Yuba Community College District

New Softball Field

ADDENDUM NO. 1

Thursday, June 29, 2023

Client Project Number:	Client Proj.:
Scale:	Sheet
Drawn By: Author	C5.1
Checked By: Checker	
Issue Date:	Issue Date:
Revit Version: 2023	Sheet of _____

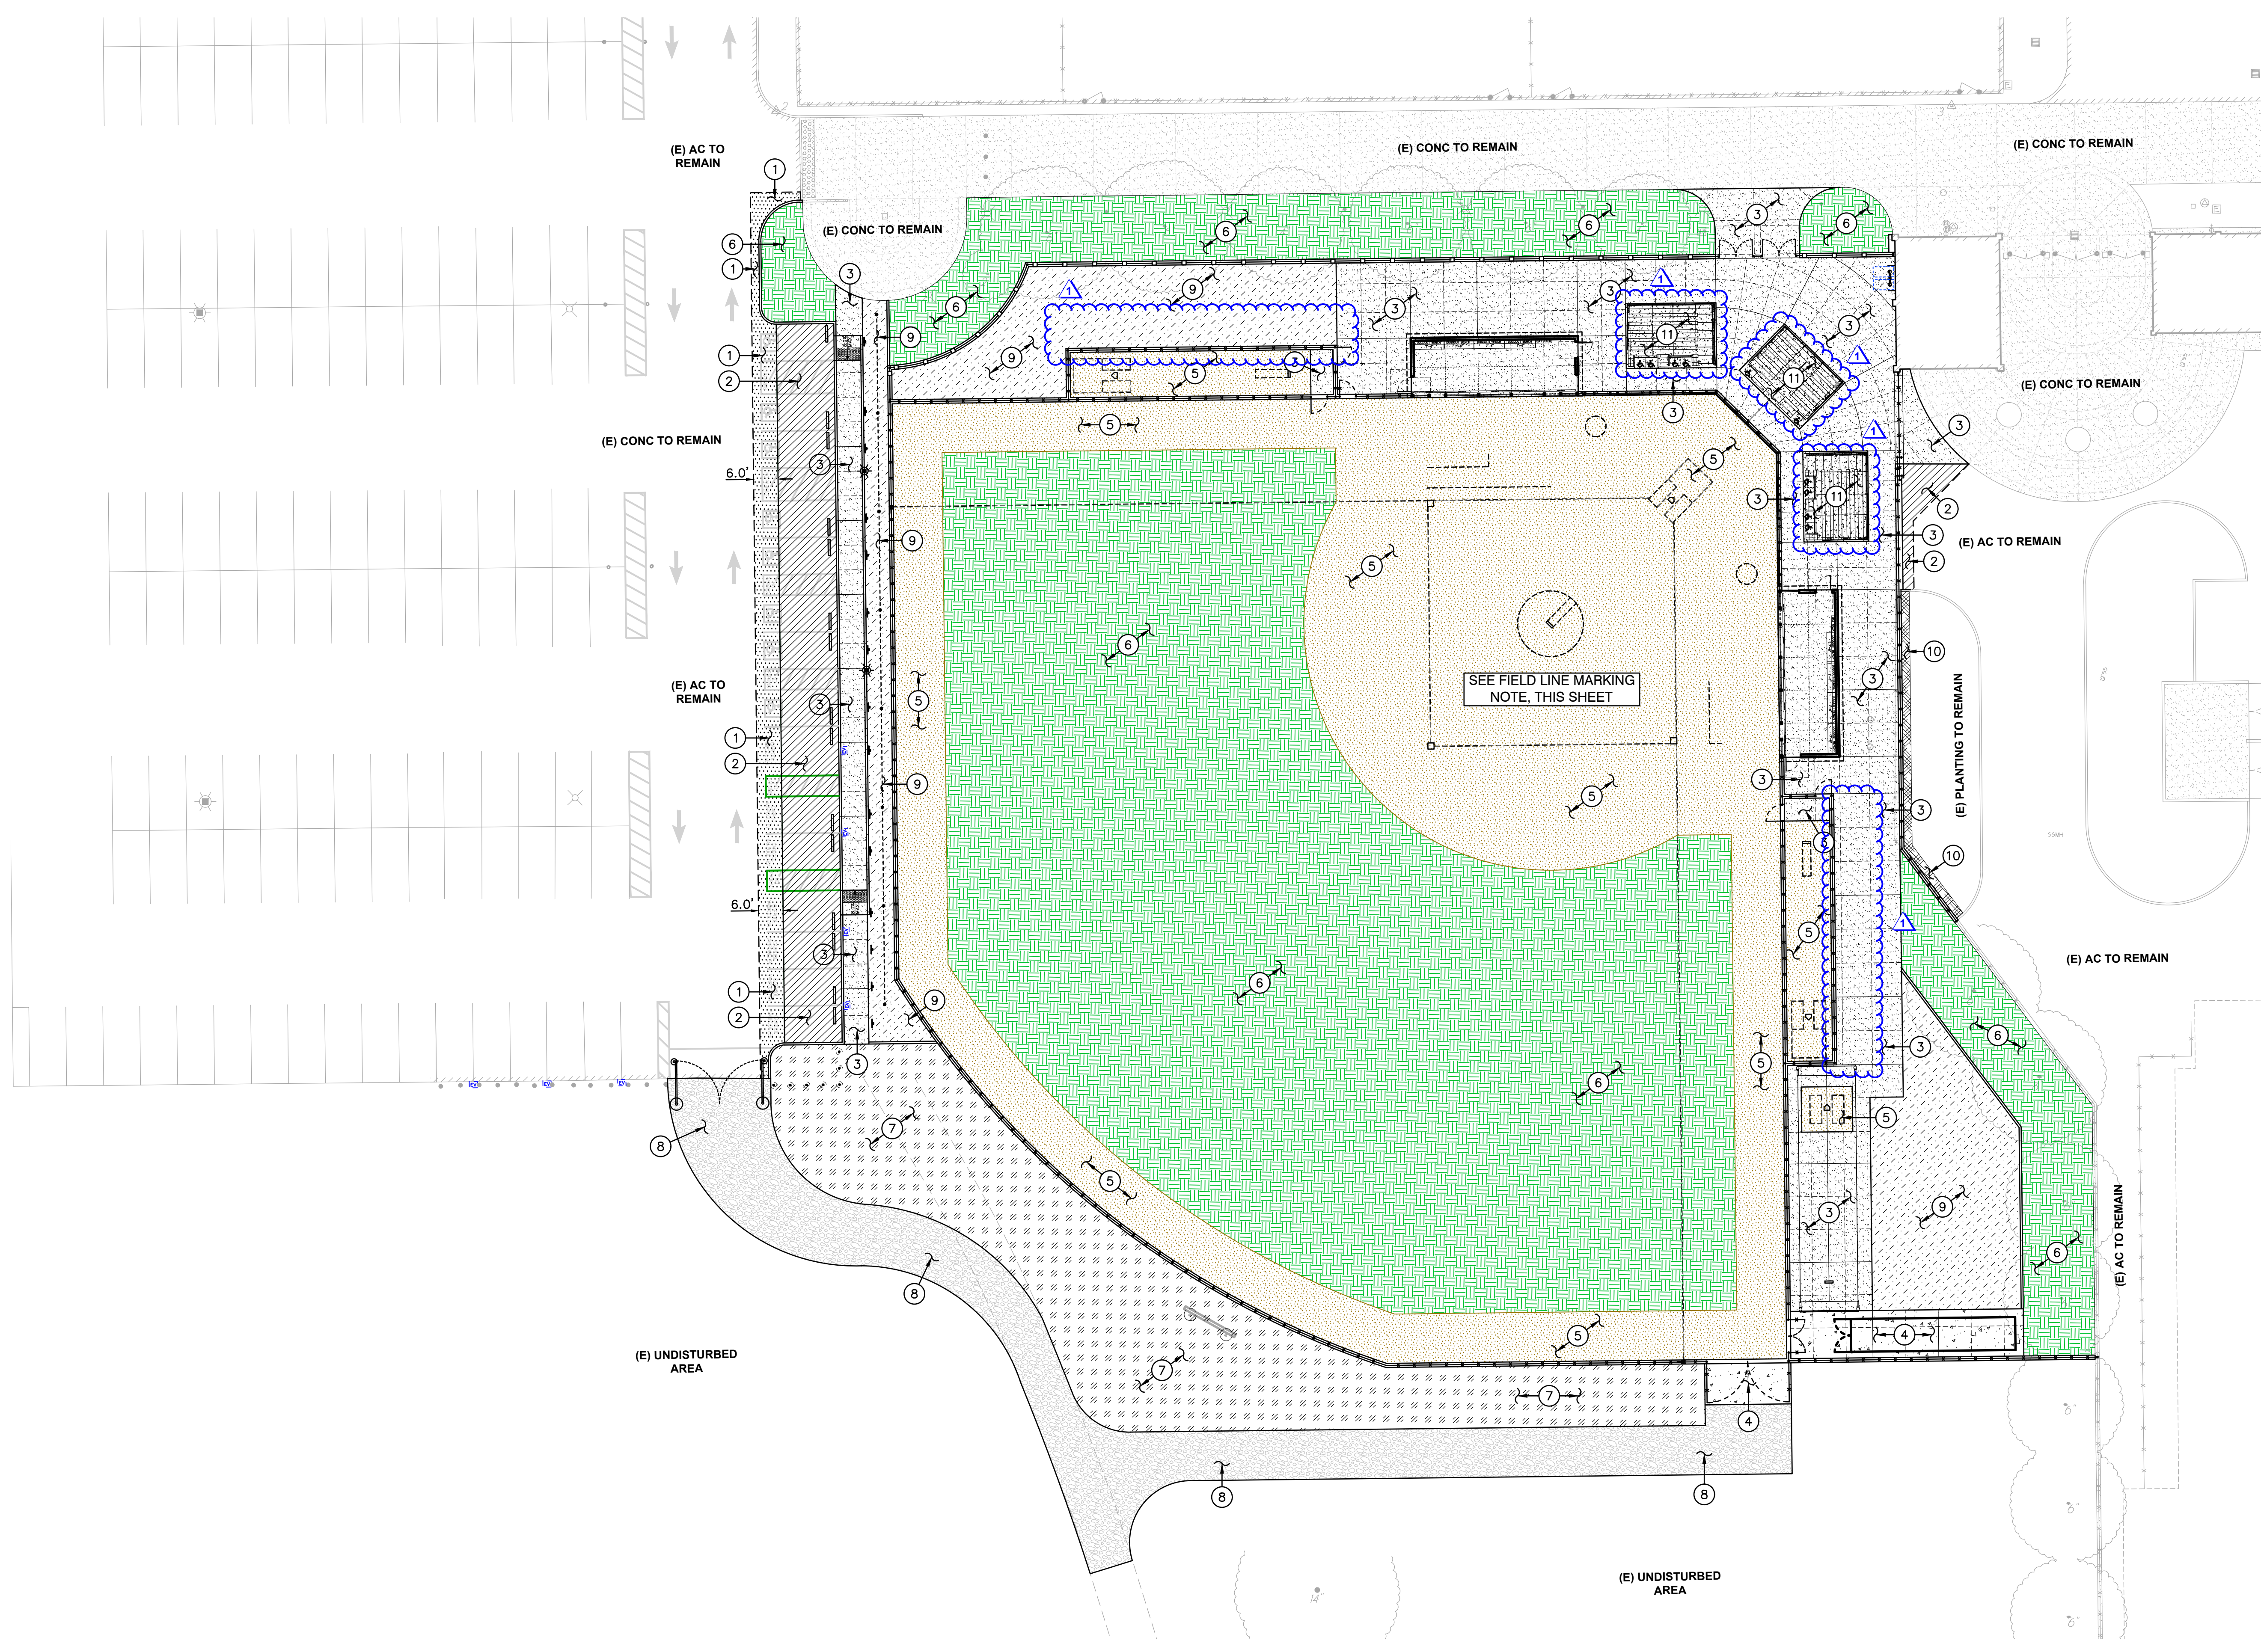
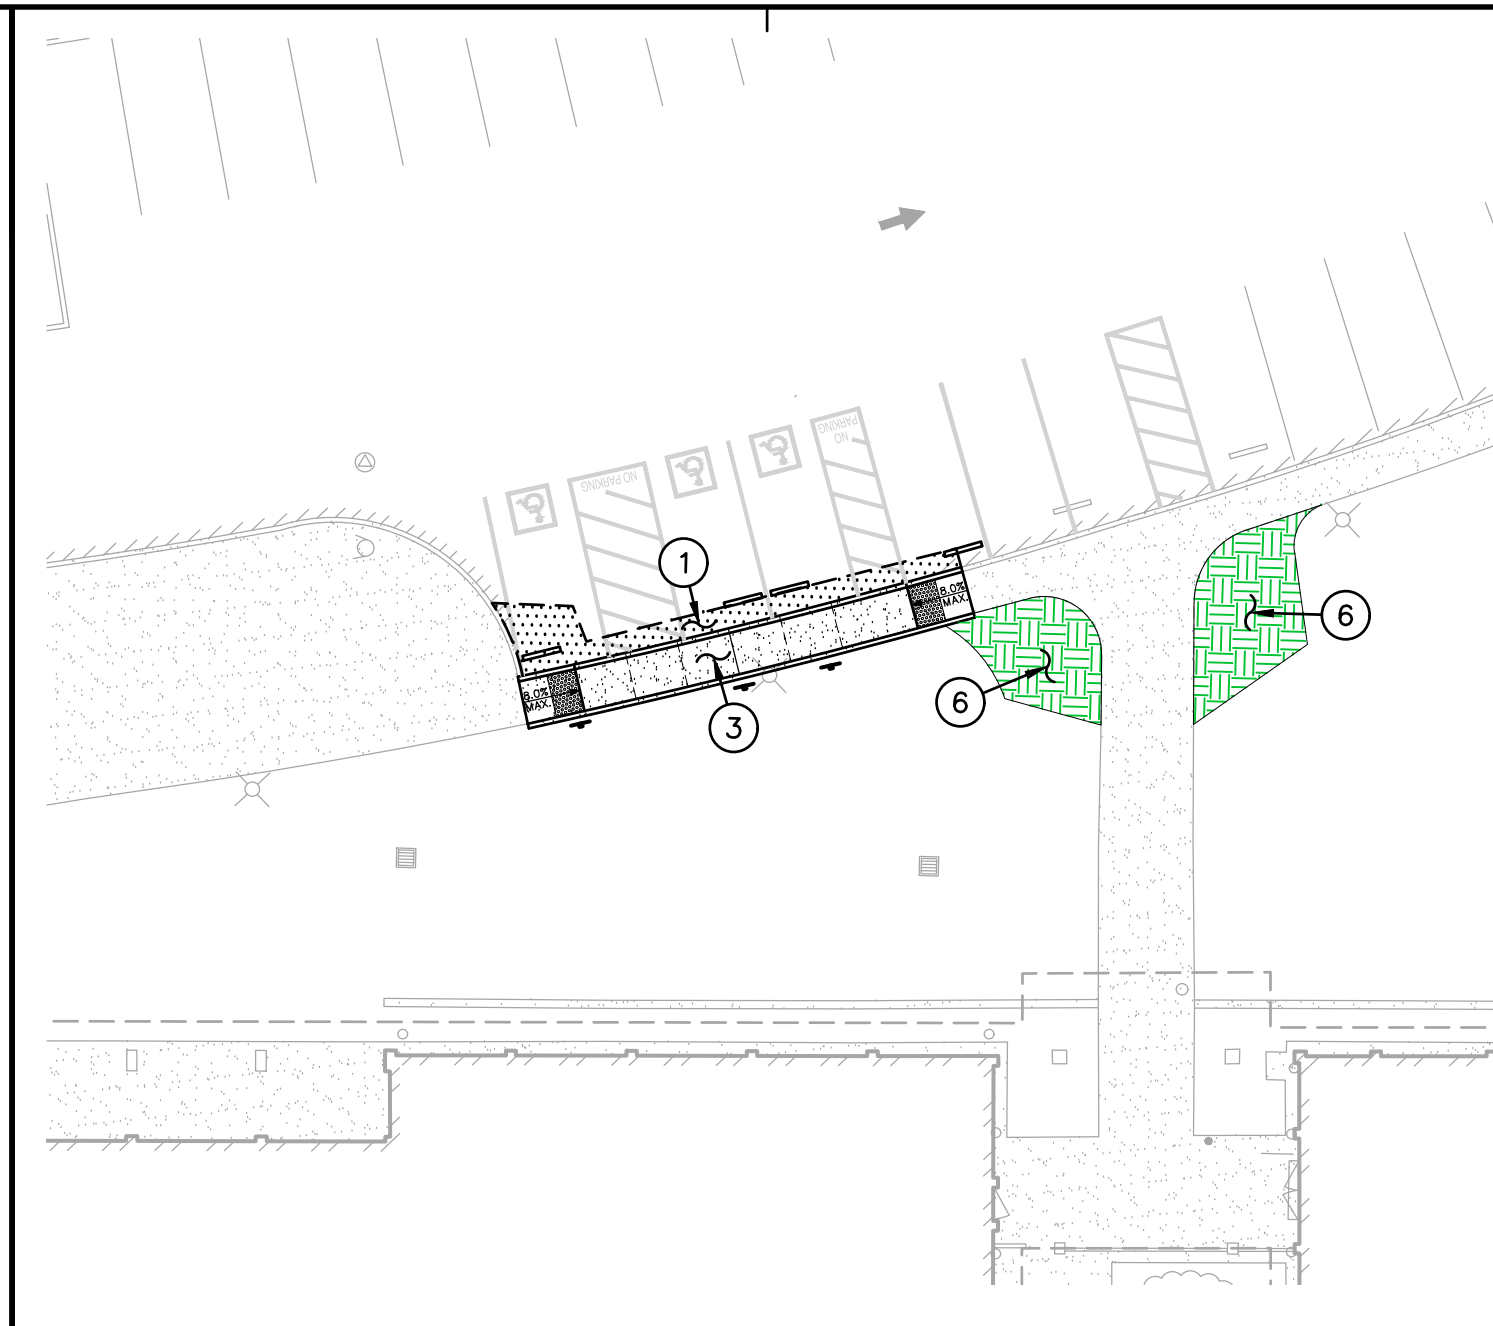
- A. **REVISE** Home and Visitors bullpen from dual to single pitching lanes.
- B. **ADD** paving Type 11 for slab/footings at bleachers.
- C. **REVISE** pavement joint locations to better coordinate with separate bleacher slab/footings.
